PROJECT RECORD DRAWINGS

Project:
ALASKA NATIONAL GUARD CSMS/UTES

ELEC. DIAGRAMS
POWER ONE-LINE
DIAGRAM
DCVR RFI
(128) (13)
(154)
(36)

Sheet No.:
E5.2

1 ELECTRICAL POWER ONE-LINE DIAGRAM

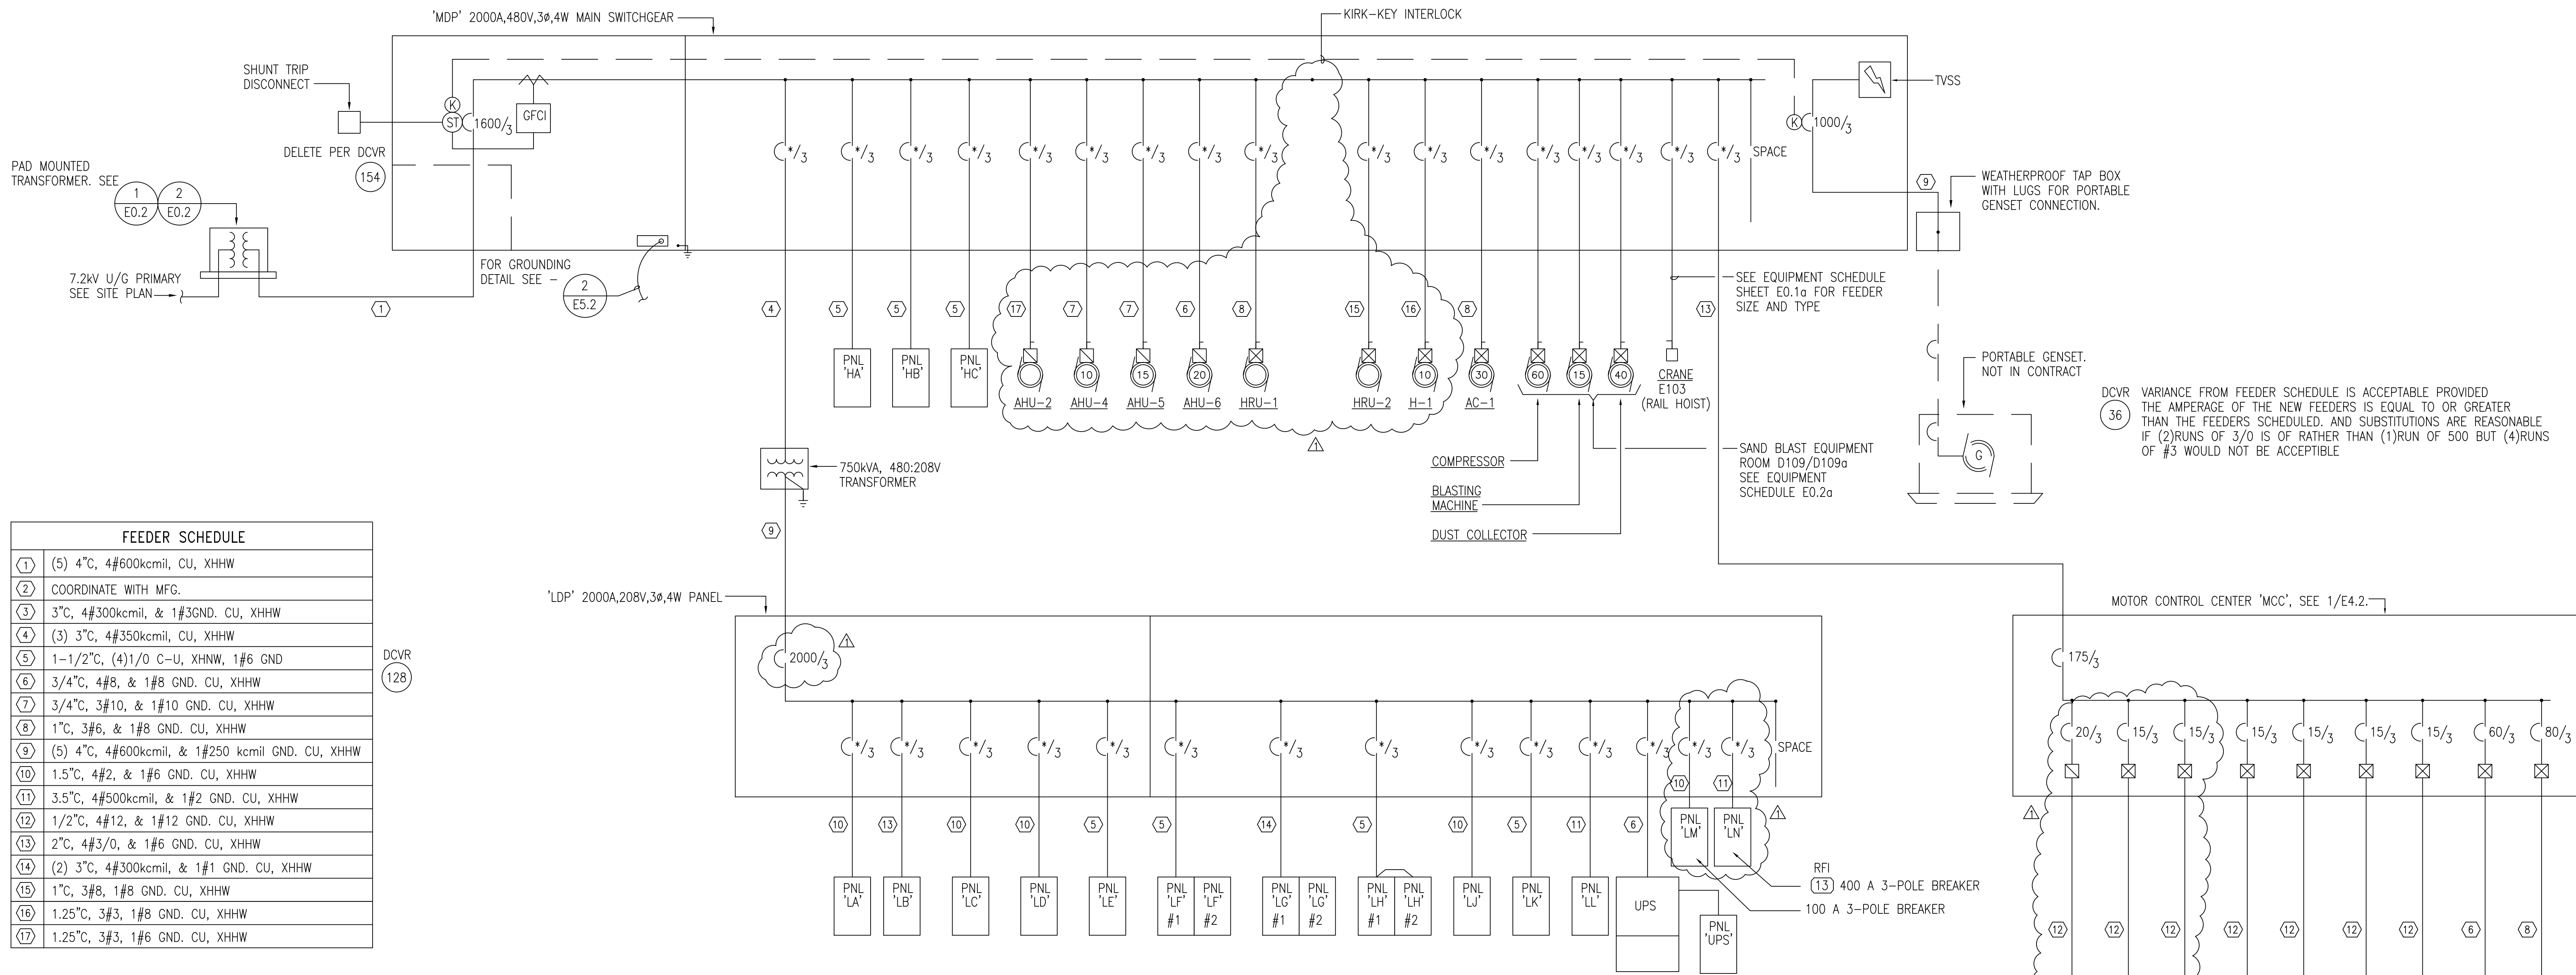
RFI FEEDERS OVER 60 A TO BE IN RIGID STEEL CONDUIT INTERMEDIATE METAL CONDUIT CAN BE SUBSTITUTED FOR RIGID METAL CONDUIT UNLESS SPECIFICALLY NOTED.
